## **OFFICIAL COORDINATION REQUEST FOR NON-ROUTINE OPERATIONS AND MAINTENANCE**

**COORDINATION TITLE-** 20LGS16 Powerhouse Roof Repair

**PROJECT-** Little Goose Lock and Dam

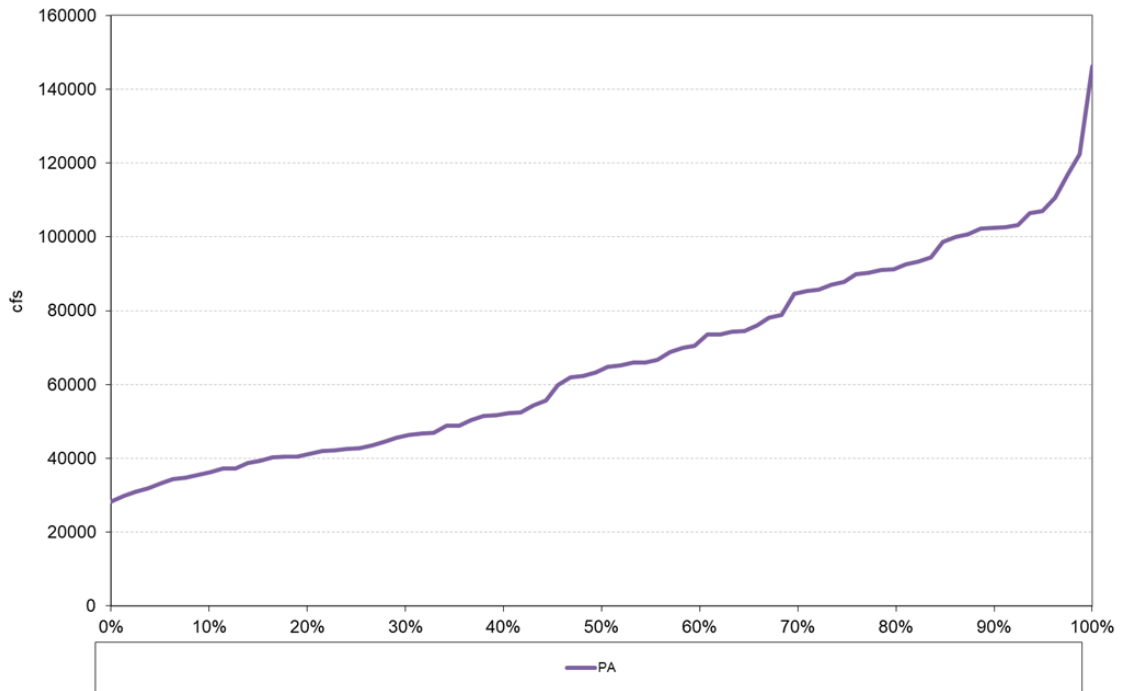
3. Can the majority of the temporary line be installed when minimal adults are passing with final work being done during the late June period?

Lee repeated what I had mentioned below, that this would mean that the powerhouse would be limited to Units 1-4, likely during the spring spill season. The combined flow for units 1-4 at the upper end of the 1% range with 100 ft of head is 69.8 kcfs. Using mean daily flow from last May and June as a rough estimate, we would have had 21 days when the project would not have been able to maintain 30% spill with only units 1-4 operating. Adding unit 6, that dropped to 4 days with uncontrolled spill. Again, just a rough estimate.

Lower Granite - April I Outflow - All Years

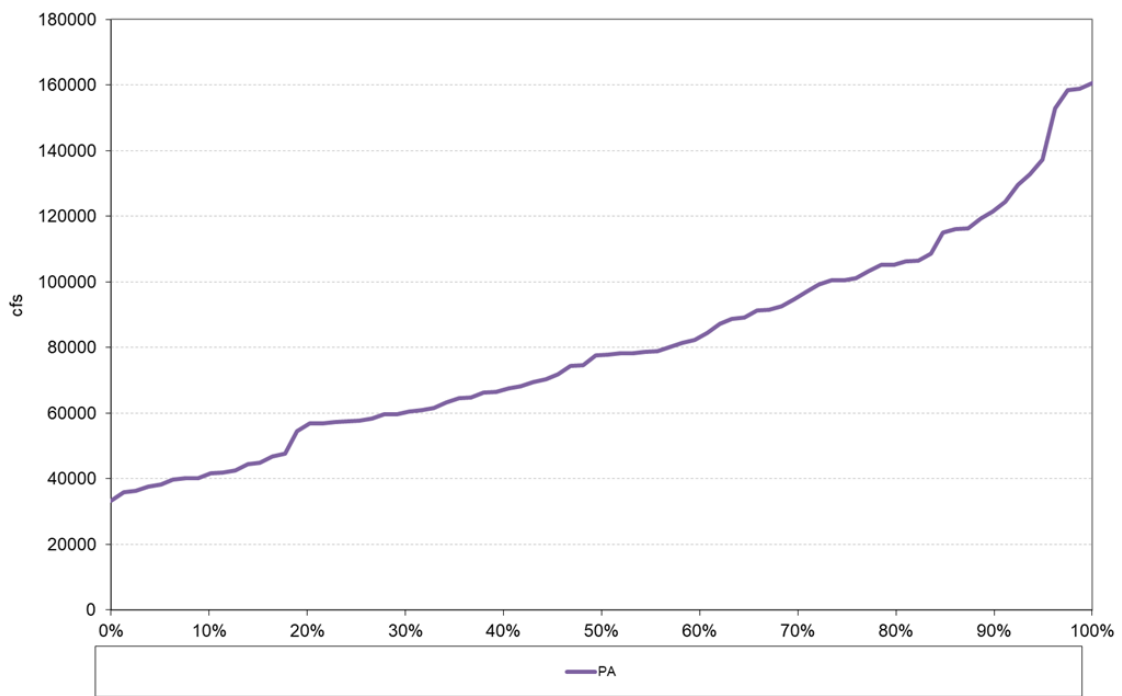
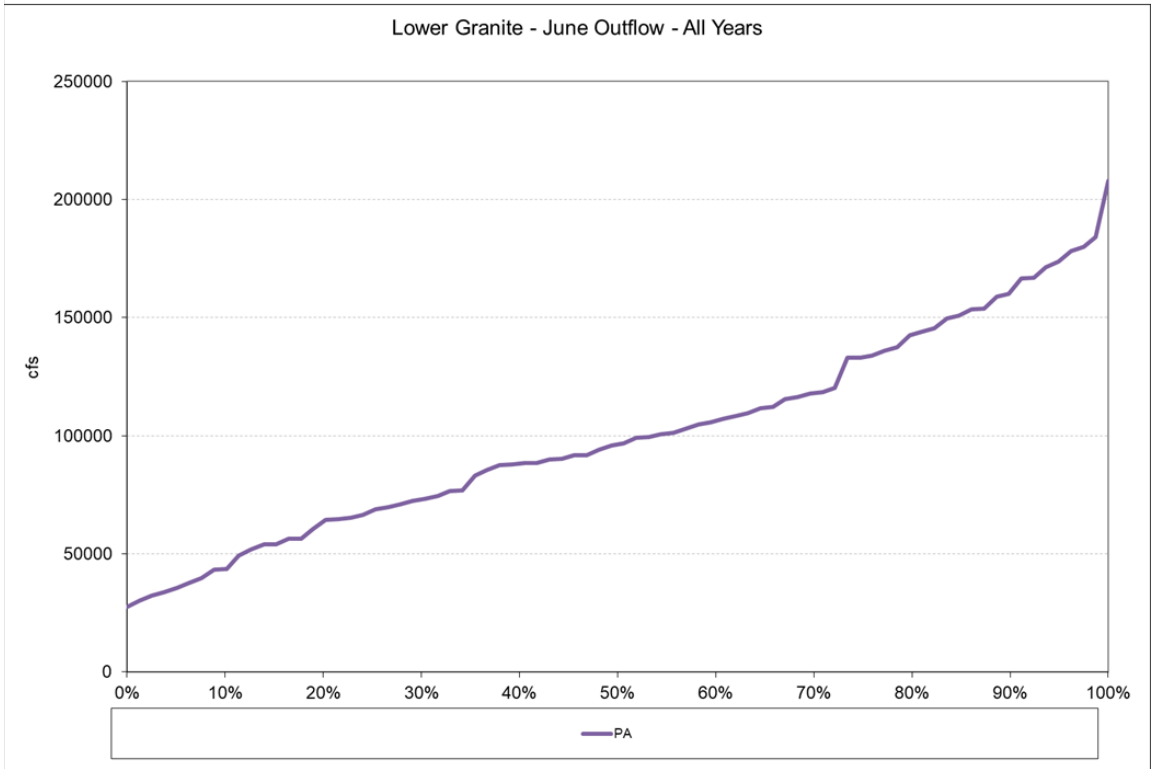
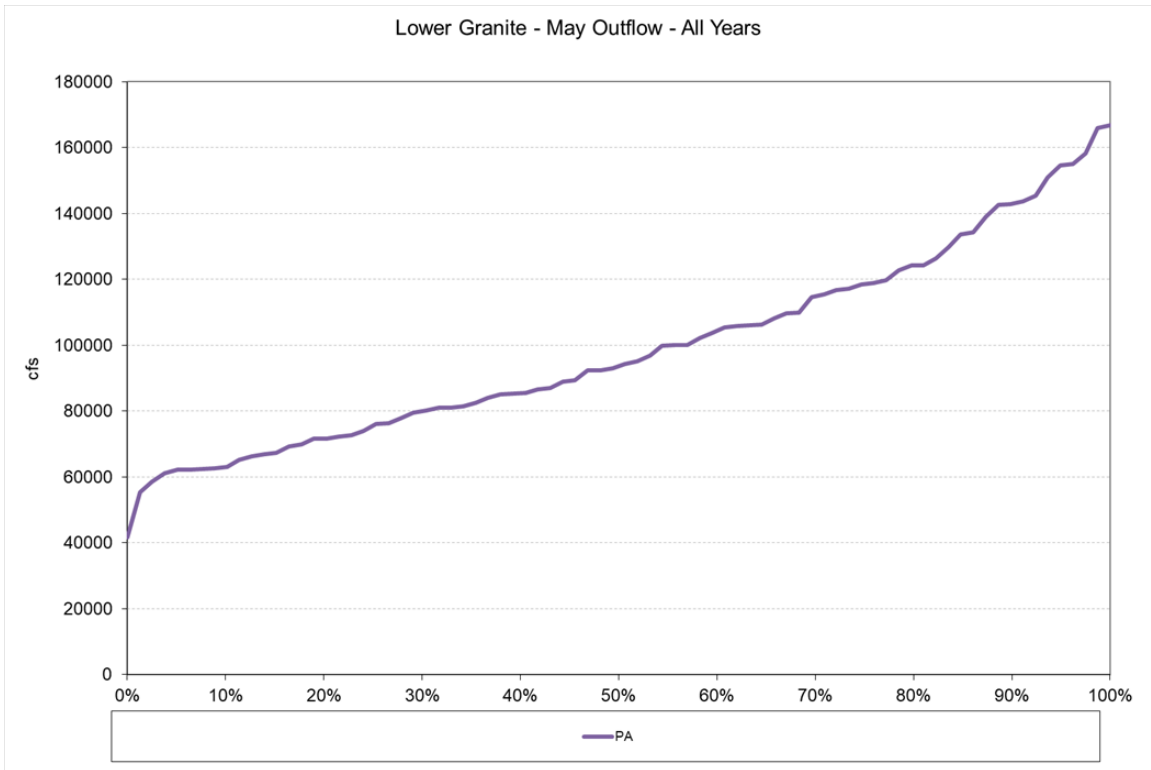
If July isn't acceptable for the four day complete powerhouse outage we could try doing it in early April. At that time all the spill could benefit juvenile fish and there are very few adults are passing. The only downside of doing it then is that the powerhouse would only have 4 units instead of 5 available. Unit 5 is down for another year so that's why it's only one less unit over the current situation. That would mean the powerhouse would be able to pass 100 kcfs (25 kcfs/unit) and approximately 80 kcfs more through the spillway during the 16 gas cap hours. During the 30% hours it would be able to pass 130 kcfs. With that capability the project could pass 150 kcfs with 8 hours at performance spill and 16 at max spill. Below are the month average graphs for flow through the Snake. During the month of April flows pick up a lot so that month has been split into two periods. -s
